County of Santa Clara

Department of Planning and Development

FILE NUMBER: PLN22-234

SUBJECT: Special Permit and Design Review Application for Small Scale Permanent Agricultural Employee Housing

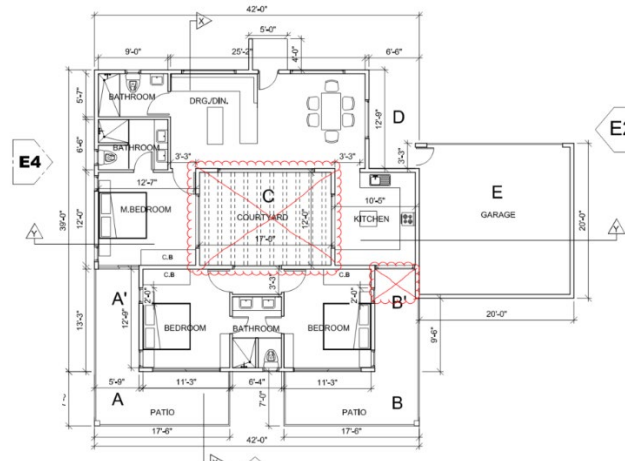
5. The floor area of the proposed agricultural housing is not correctly calculated. Please update the floor area calculation on Sheet A01 to include the area of the covered porch (~20 sq.ft.) and Courtyard (204 sq.ft.) [shown in the bellow picture]. As per the County of Santa Clara Zoning Ordinance section §1.30.030, "floor area" includes "the total area of any attached garage, and any carport, porch or similar attached structure or feature that is both: (a) covered, and (b) greater than 50% enclosed by perimeter walls."

Note: Per Section 4.10.040(C), individual units used as small scale permanent agricultural employee housing shall not exceed 1,200 square feet.
